COUNCIL ASSESSMENT REPORT
SYDNEY WESTERN CITY PLANNING PANEL

PANEL REFERENCE & DA NUMBER	PPSSWC-419 – DA-216/2024
PROPOSAL	Concept Development Application for the demolition of all existing structures, amalgamation of lots and boundary adjustment, and the construction of two commercial towers of 17 and 28 storeys above a 4 storey podium with 2.5 levels of basement car parking and a pedestrian through-site link connecting George Street and Macquarie Mall
ADDRESS	Lot 2 DP 591959 – 132 Macquarie Street, Liverpool Lot 2 DP 90210 – 127 George Street, Liverpool Lot 1 DP 657061 – 131 George Street, Liverpool Lot 1B DP 401936 – 146 Macquarie Street, Liverpool Lot 1 DP 620512 – 152 Macquarie Street, Liverpool
APPLICANT	Mr. G De Chalain
OWNER	Copping and Vartuli Pty Ltd; FBDM Pty Ltd; Sydrom Pty Limited; Deemhire Pty Limited; Liverpool City Council
DA LODGEMENT DATE	7 May 2024
APPLICATION TYPE	Concept DA
REGIONALLY SIGNIFICANT CRITERIA	Clause 2, Schedule 6 of <i>State Environmental Planning Policy (Planning Systems) 2021</i> Clause 3, Schedule 6 of <i>State Environmental Planning Policy (Planning Systems) 2021</i>

Figure 16: Indicative Macquarie Street Elevation (Drawing No. A801, Issue D)

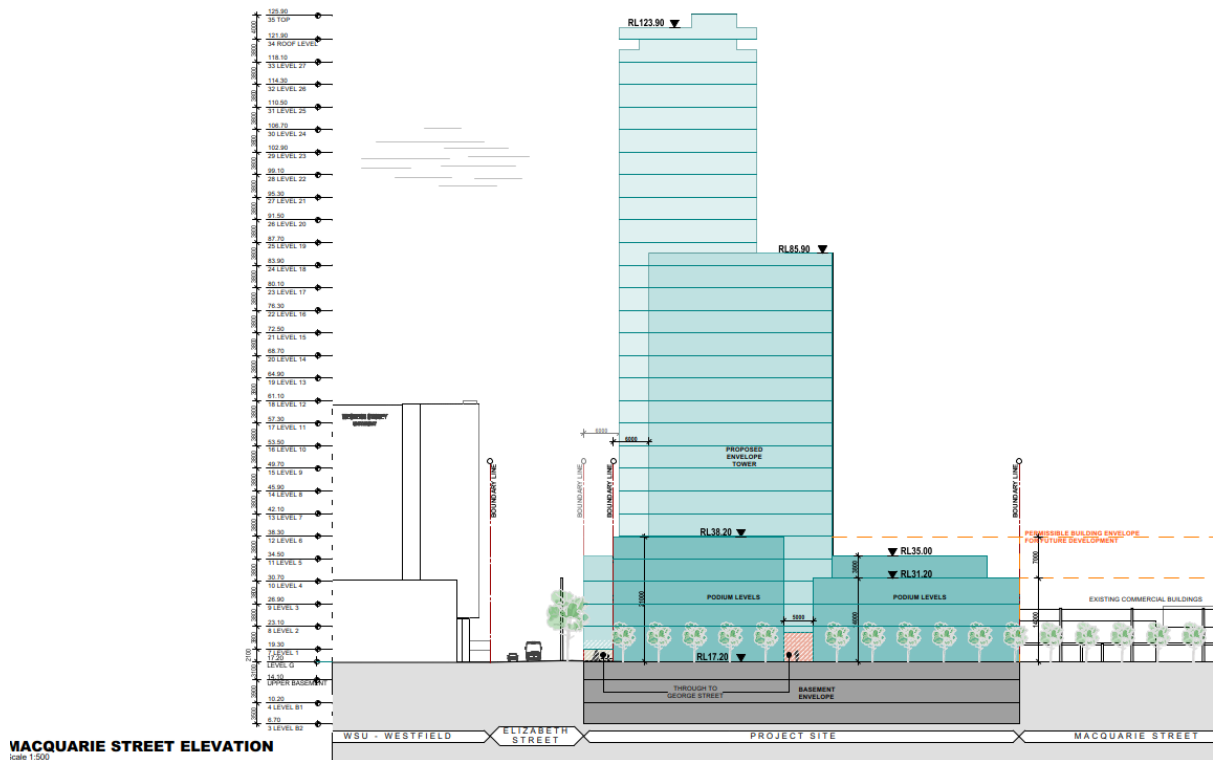
The remainder of the site, being 146 and 152 Macquarie Street, is prescribed a 21m building height. The plans submitted identify a maximum 17.8m height, as illustrated in Figure 16. While this does not account for any roof structures or lift overrun, these are reasonably likely to be contained within the 21m height.

Figure 22: Land Acquisition and Dedication Plan (Source: Drawing No. A304 Issue D)

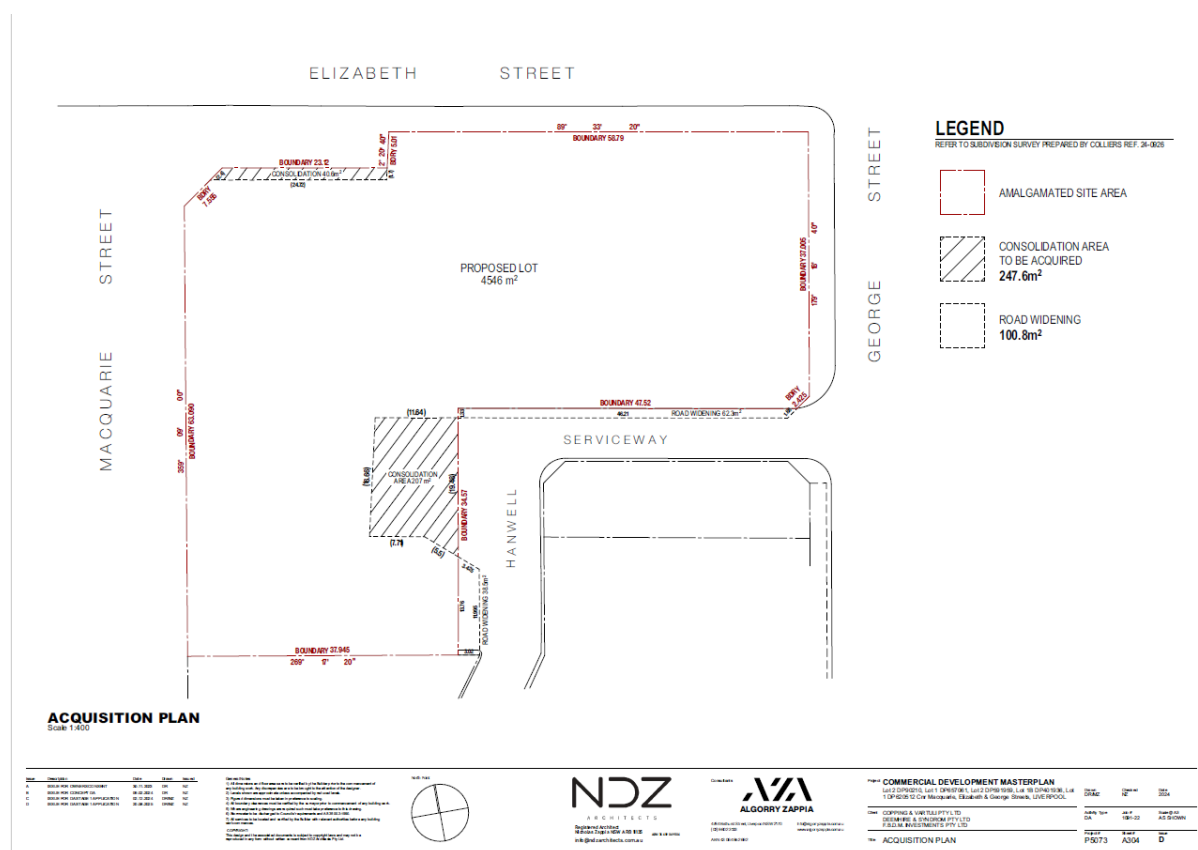
The plan in Figure 22 identifies the new total site area as 4,546m². It is noted that the calculation of the land to be dedicated and acquired has a net site area increase of 146.6m². The areas provided equate to a new site area of 4,540.6m², less than the stated 4,456m². This discrepancy would need to be addressed at the built form development application stage.

Figure 30: Level 6 Floor Plan (Source: Drawing No. A610, Issue A)

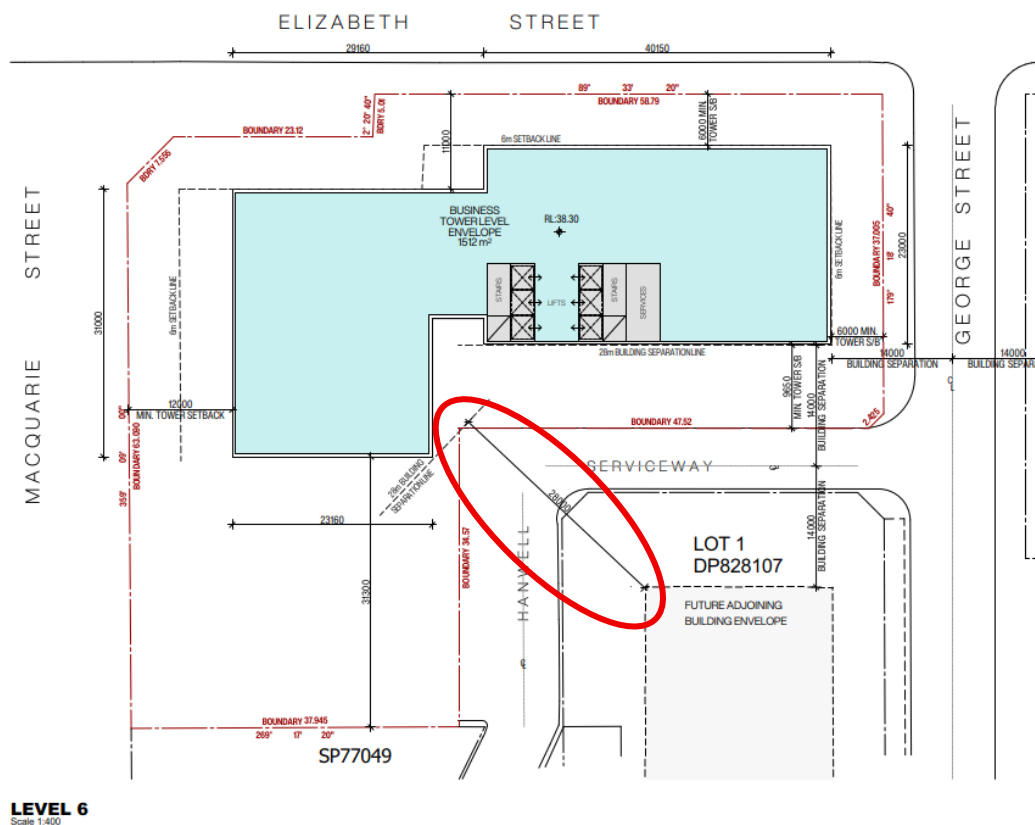
The amended architectural plans submitted include floor plans and elevations showing the 28 metre separation from the towers to the approved development on the opposite side of Hanwell Serviceway to the south-east. The 28m separation distance is circled in red in Figure 30.

Figure 30: Extract of Figure 4-12 Through-site Links from Part 4 of the DCP (site outlined in black)

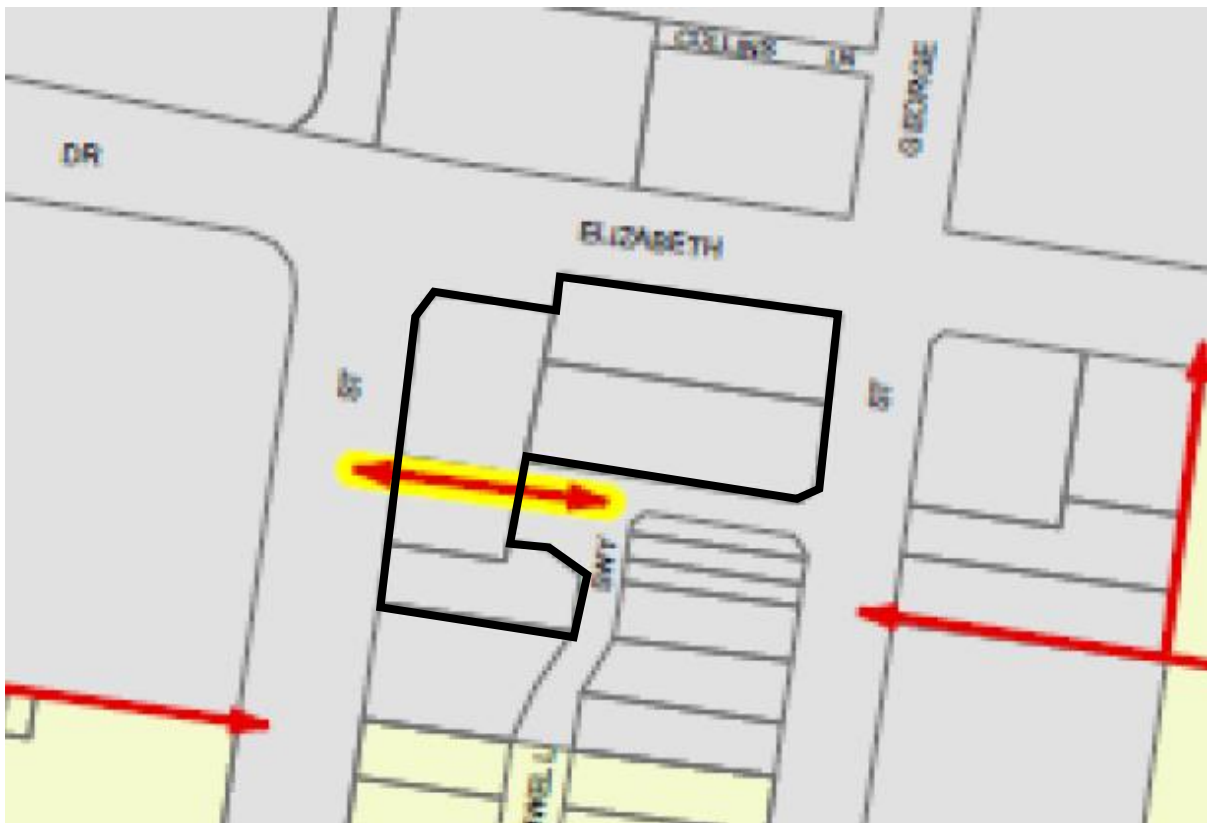
A through-site link has been incorporated into the proposal, generally in the indicated location in the figure above (see Figure 22 for the proposed link). The link is 5m wide and connects Macquarie Mall and George Street, delivering the intent of the Pedestrian Arcades and Through-site Links controls that apply in this instance.
